**Public Input No. 3085, Assigned to Code-Making
Panel 1, Refer to Code-Making Panels 2 - 18**

Public Input No. 3085-NFPA 70-2023 [Global Input]

This Global Public Input is for all Technical Committees and review their informational notes and the requirements in the NEC Style Manual Section 2.1.10 for informational notes.

FIGURE 1: EASYPOWER® SOFTWARE ONE-LINE DIAGRAM EXAMPLE

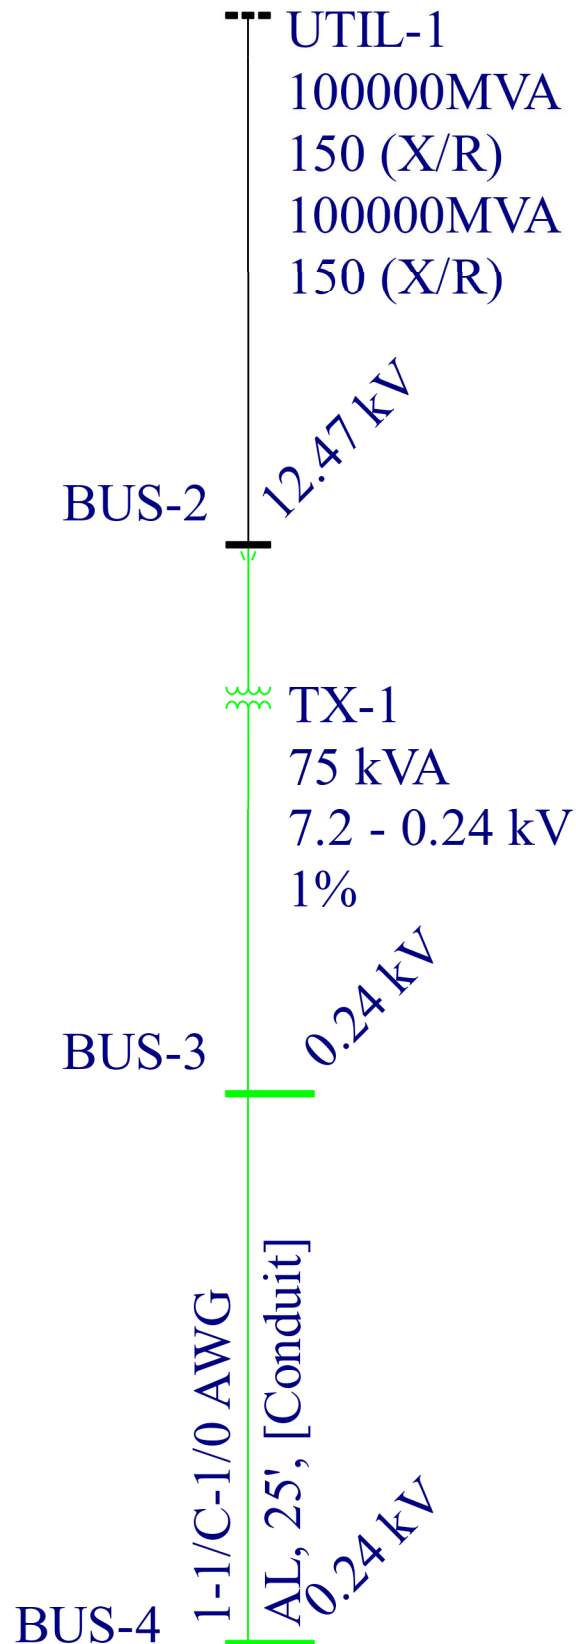
Bentley Systems (Bentley) was asked to perform single-phase short calculations to aid the AFCI Consortium in their comment process for the latest revision to NFPA 70 National Electrical Code (NEC). Specifically, AFCI Consortium is interested in comparing single-phase short circuit calculations performed using the EasyPower® software on the secondary sides of service entrance transformers of varying impedances and secondary cable lengths/sizes with results obtained using the point-point short circuit calculation procedure. Figure 1 shows an example of the EasyPower® software one-line diagram used for single-phase short circuit calculations.

Figure 1 shows an example of the EasyPower® software one-line diagram used for single-phase short circuit calculations. To produce the various short circuit calculation results, transformer impedances and secondary service entrance cable values were adjusted in the EasyPower® software prior to each calculation, as required.

Figure 1

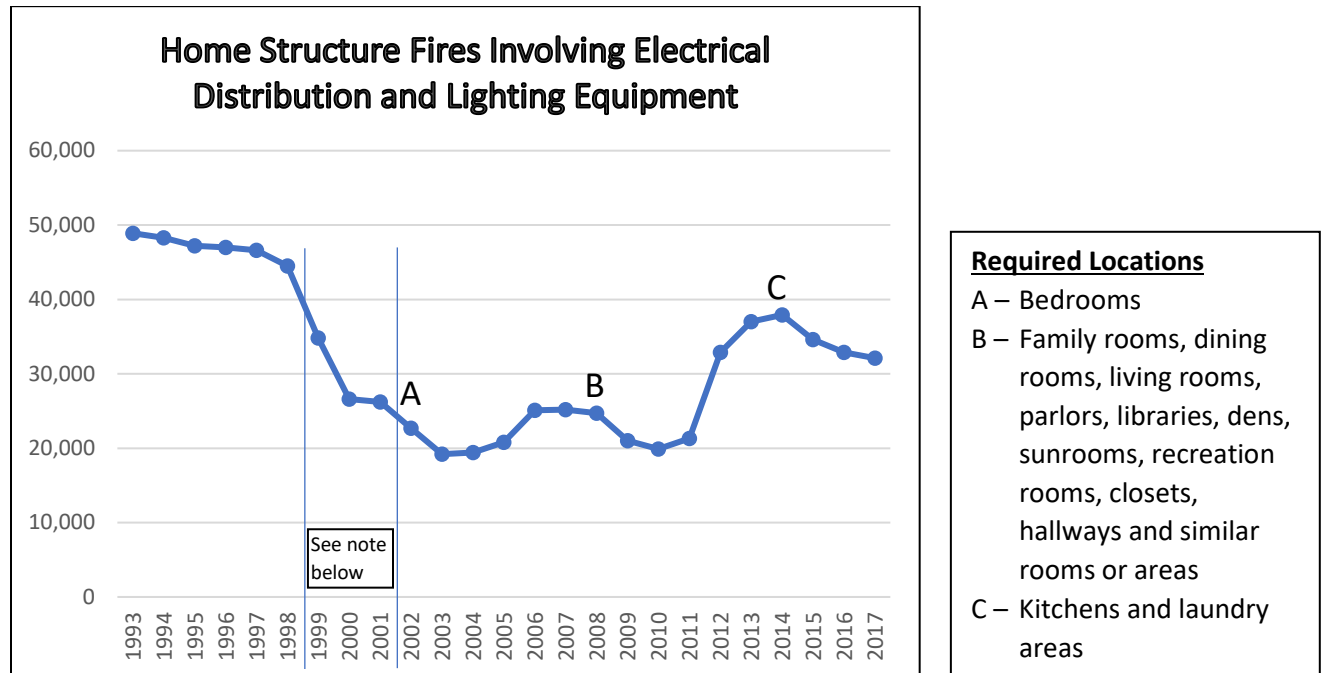
The current fire data coming from NFPA should give us pause. There is no empirical, real-world data we can point to supporting the expansion of AFCI requirements. Quite the opposite—we now see that the installation of tens of millions of AFCI devices has not had a noticeable effect on fire data. As millions of AFCI devices were being installed, home fires involving electrical distribution and lighting equipment experienced a dramatic increase between 2010 and 2014 (see Figure 1)—the numbers of fires jumped from 19,900 to 37,900 in that period.

Figure 2: GFCI Protection in Homes Versus Electrocutions 1975 to 2018 (Source: A NEMA Ground Fault Personnel Protection Section Article entitled “GFCI Receptacles: Consumer Protection Personified” June 2020, Revision 2).

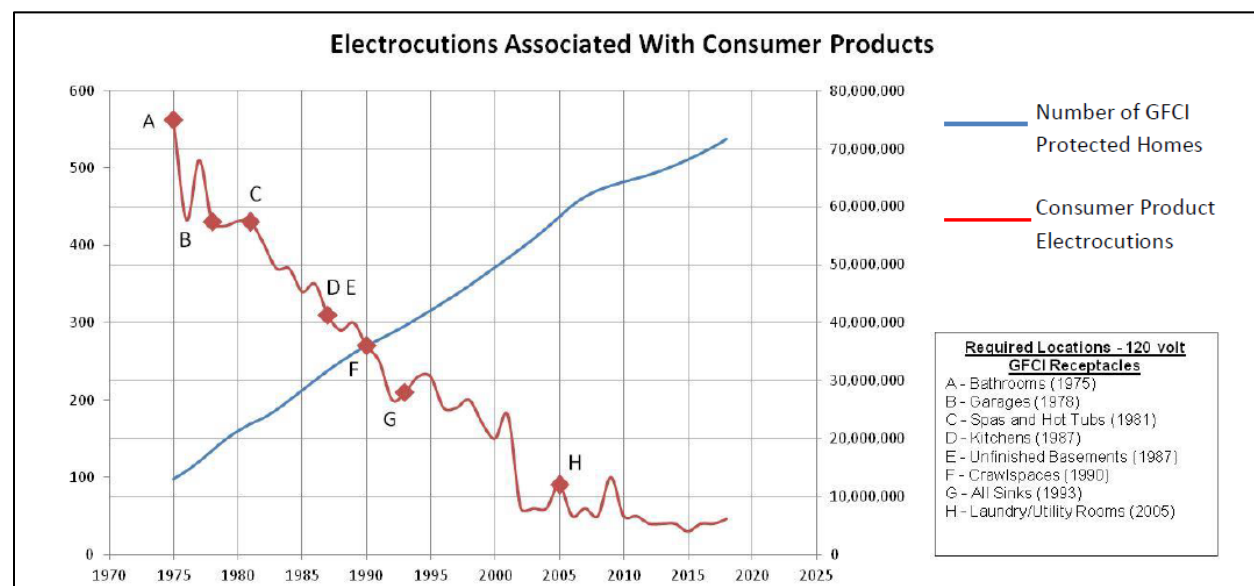
In contrast to the data surrounding AFCIs, there is a clear relationship between the early adoption of GFCIs and the reduction in electrocutions (see Figure 2). This is the effect we should be expecting from AFCIs as well, but we are not seeing anything similar to the benefit GFCIs have provided.

Figure 3

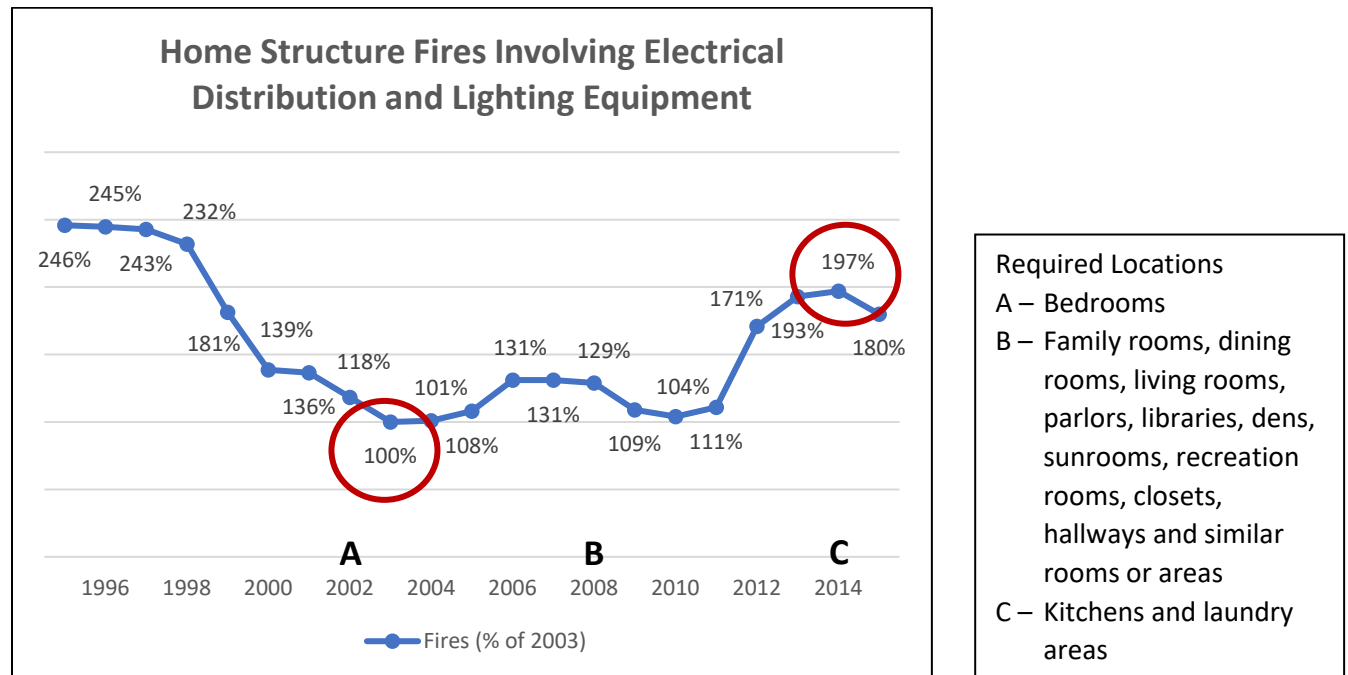
Another way to look at the AFCD data is to show the increase in fires as a percent of the low water mark of 2003. After 2008, when the bulk of circuits in a home were required to be covered by an AFCD device, fires incidents reached their highest number since 1998—a nearly 100% increase over 2003.

Figure 1

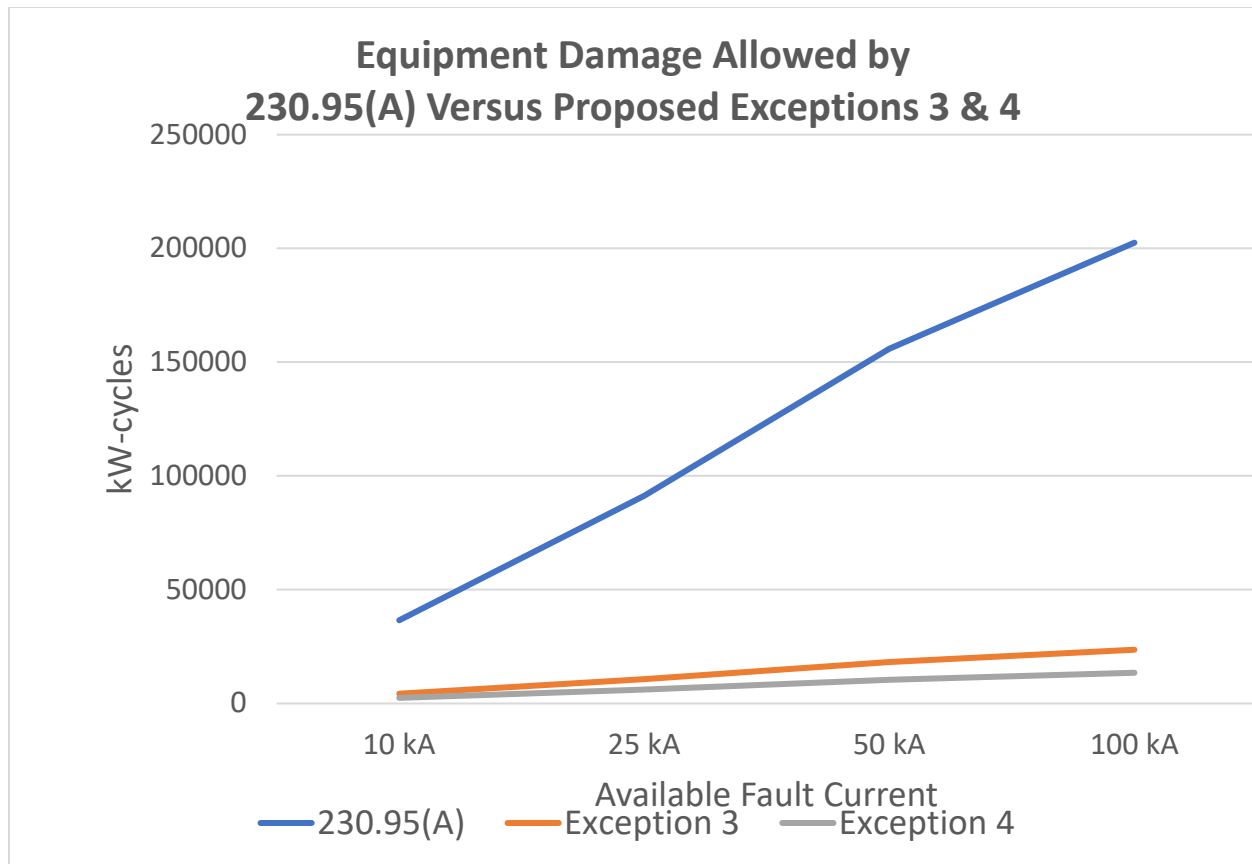
As allowed by 230.95(A). The IEEE 1584-2018 minimum arcing current is 6.09kA. Using the maximum 230.95(A) opening time of 60 cycles, the equipment damage is (6.09 kA X 60 cycles X 100 arcing volts) = 36,540 kW-cycles. See Figure 1.

As allowed by 230.95(A). The IEEE 1584-2018 minimum arcing current is 15.21kA. Using the maximum 230.95(A) opening time of 60 cycles, the equipment damage is (15.21 kA X 60 cycles X 100 arcing volts) = 91,260 kW-cycles. See Figure 1.

breakers (6,084 kW-Cycles) is less than 7% of the worst-case damage allowed by 230.95(A) (91,260 kW-cycles). See Figure 1.

As allowed by 230.95(A). The IEEE 1584-2018 minimum arcing current is 25.98kA. Using the maximum 230.95(A) opening time of 60 cycles, the equipment damage is (25.98 kA X 60 cycles X 100 arcing volts) = 155,880 kW- cycles. See Figure 1.

As allowed by 230.95(A). For an available fault current of 100kA, the IEEE 1584-2018 three phase minimum arcing current is 33.75 kA. Using the maximum 230.95(A) opening time of 60 cycles, the equipment damage is (33.75 kA X 60 cycles X 100 arcing volts) = 202,500 kW-cycles. See Figure 1.

As allowed by Proposed Exception No. 3. The IEEE 1584-2018 minimum arcing current is 33.75 kA. Assuming the maximum opening time of 4.2 cycles (0.07 seconds) for 240.67(B), the equipment damage is (33.75 kA X 4.2 cycles X 100 arcing volts) = 14,175 kW-cycles. Assuming an opening time of 7 cycles for 240.67(B)(1) and (B)(3), the equipment damage is (33.75 kA X 7 cycles X 100 arcing volts) = 23625 kW-cycles. Assuming an opening time of 1/2 cycle for 240.67(B)(4), the equipment damage is (33.75 kA X 0.5 cycles X 100 arcing volts) = 1688 kW-cycles. Worst-case damage for the minimum arcing current with this proposed exception for fusible switches (23625 kW-cycles) is less than 12% of the worst-case damage allowed by 230.95(A) (202,500 kW-cycles). See Figure 1.

As allowed by Proposed Exception No. 4. For an available fault current of 100kA, the IEEE 1584-2018 minimum arcing current is 33.75 kA. Assuming an opening time of 4 cycles for 240.87(B)(1), (B)(2), or (B)(4), the equipment damage is (33.75 kA X 4.0 cycles X 100 arcing volts) = 13,500 kW-cycles. Assuming an opening time of 3 cycles for 240.87(B)(5) or (B)(6), the equipment damage is (33.75 kA X 3 cycles X 100 arcing volts) = 10,125 kW-cycles. Worst-case damage for the minimum arcing current with this proposed exception for circuit breakers (13,500 KW-Cycles) is less than 7% of the worst-case damage allowed by 230.95(A) (202,500 kW-cycles). See Figure 1.

Figure 1 shows that equipment damage allowed by this Public Input is always, from 10,000 amperes available through 100,000 amperes available, just a small fraction of the equipment damage allowed by 230.95(A).

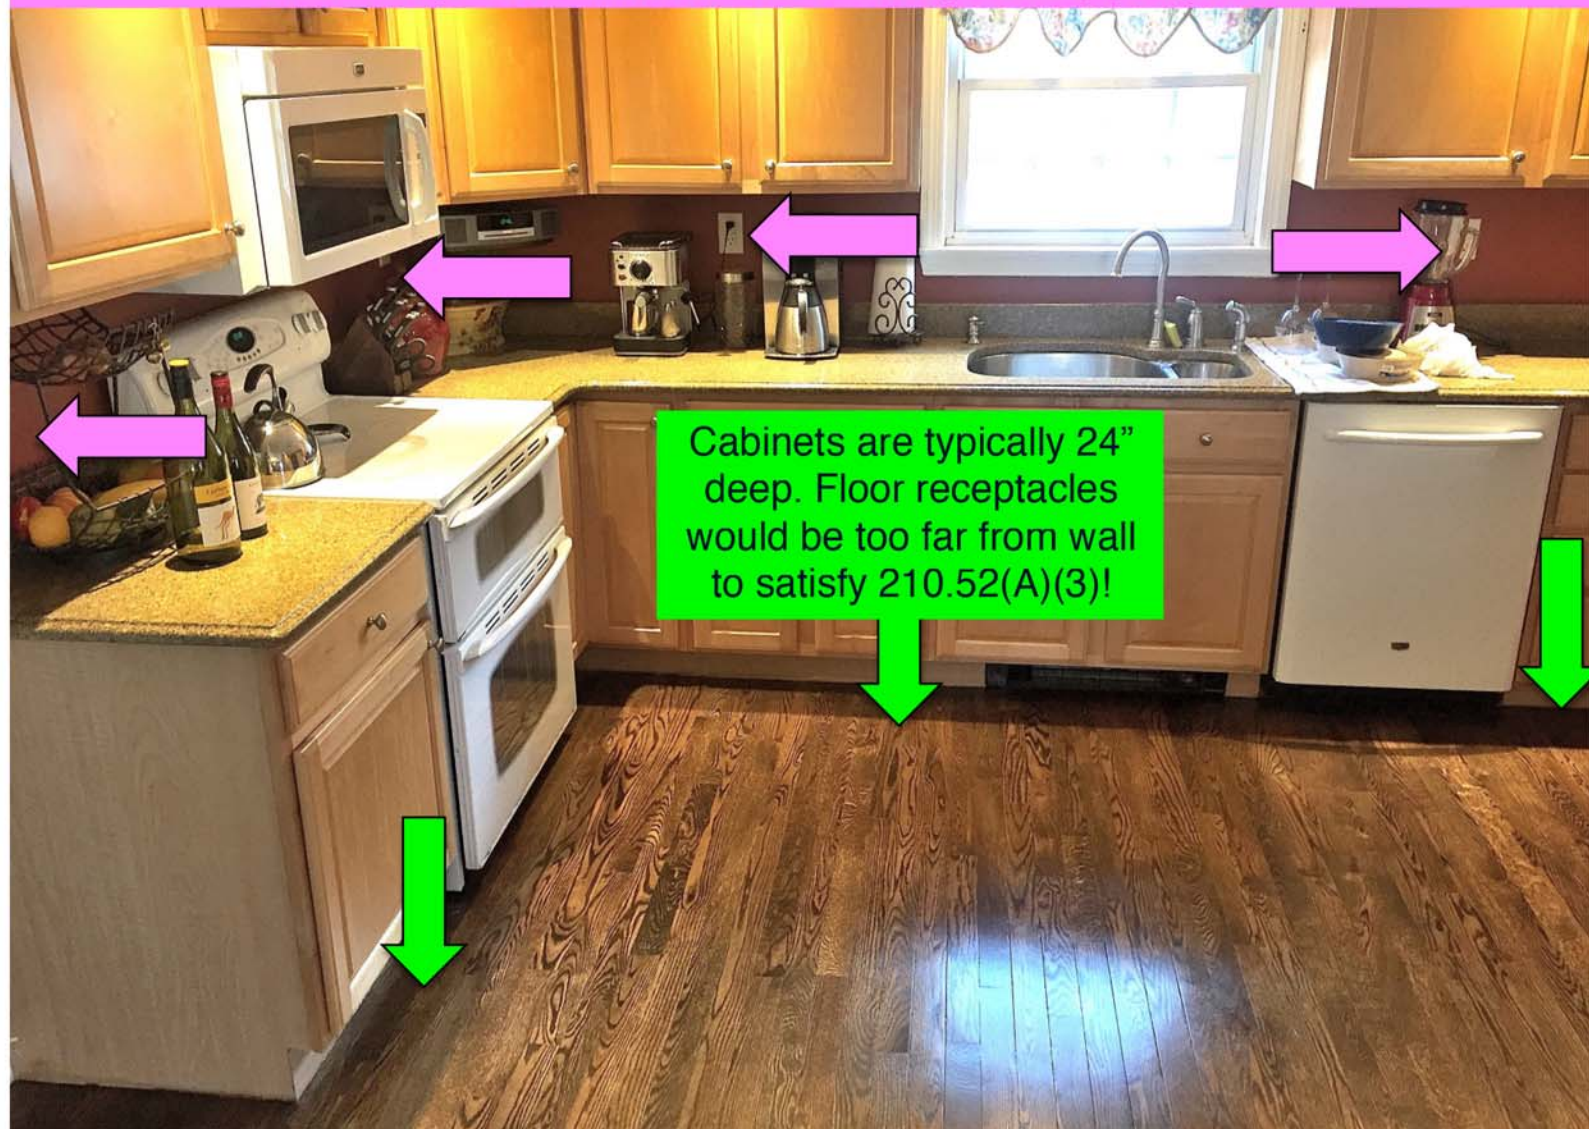
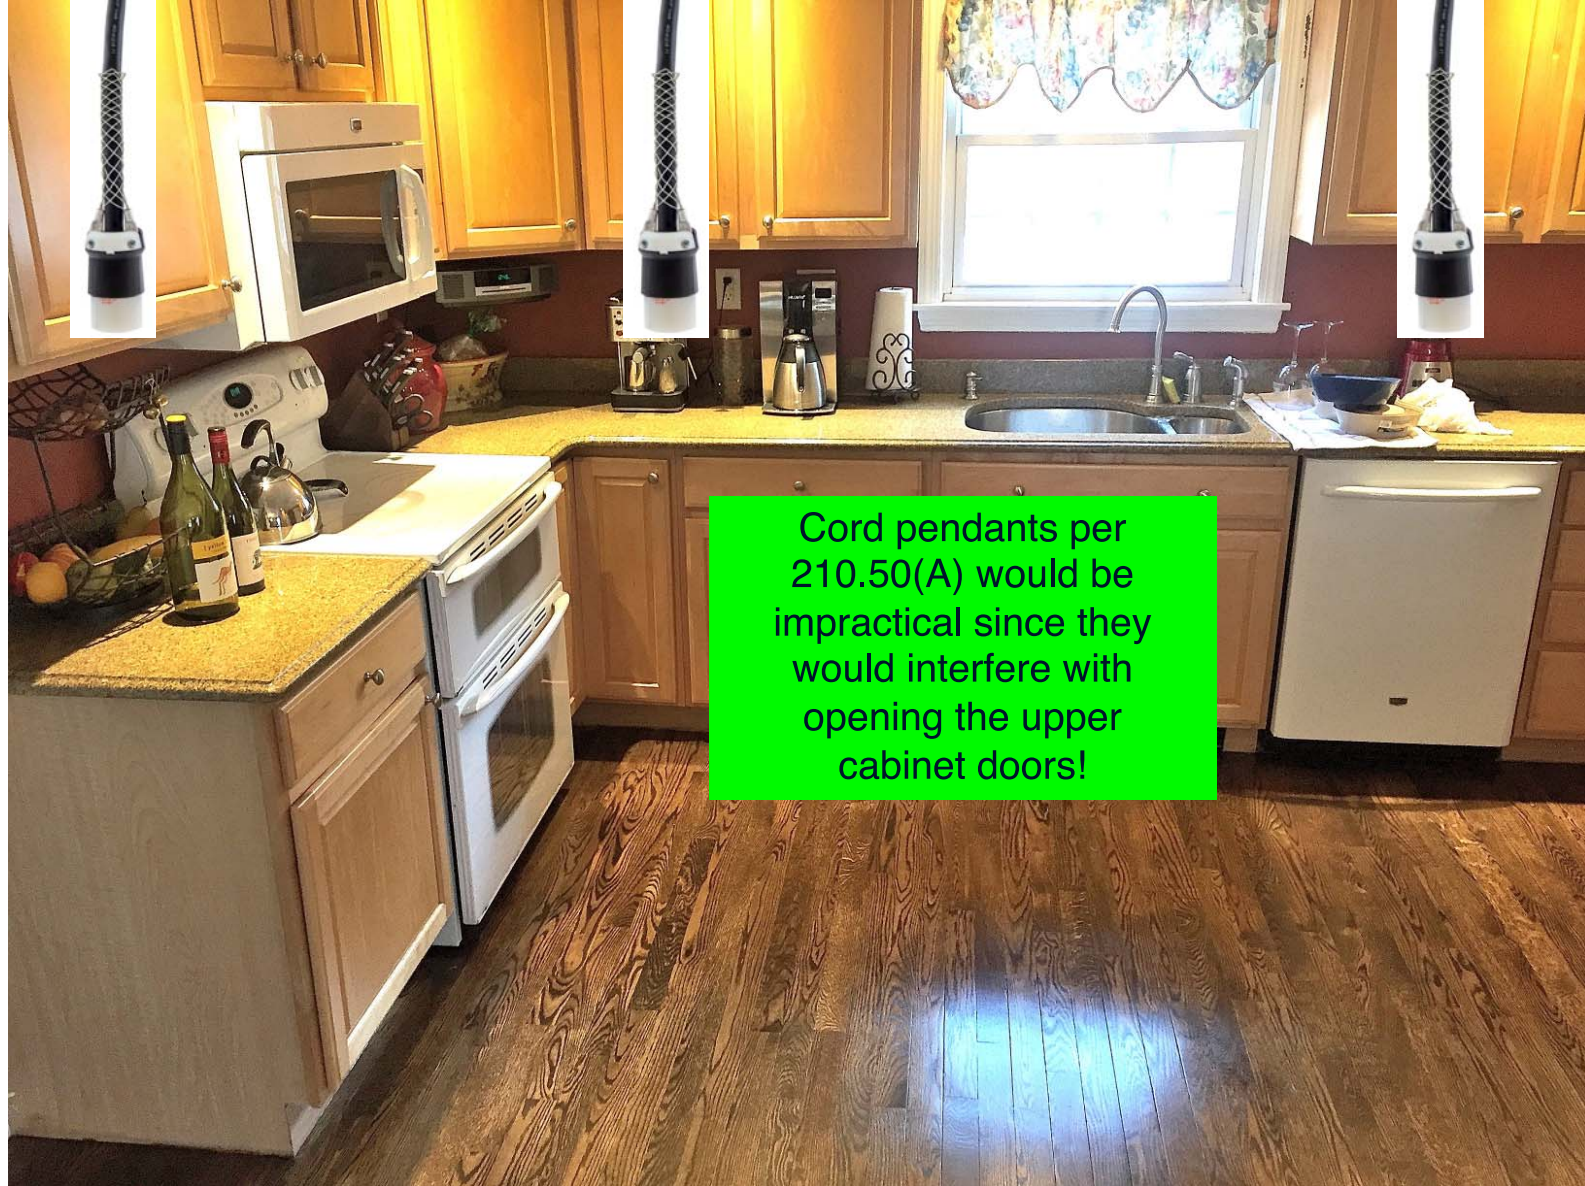
This means the wall spaces at kitchen cabinets having countertops are included in this requirement!

These receptacles cannot be used to satisfy 210.52(A) requirements!

But, according to 210.52(A)(4) and 210.52(C), Receptacles installed for countertop and similar work surfaces SHALL NOT be considered as the wall space receptacle outlets required by 210.52(A)

These receptacles cannot be used to satisfy 210.52(A) requirements!

These receptacles cannot be used to satisfy 210.52(A) requirements!
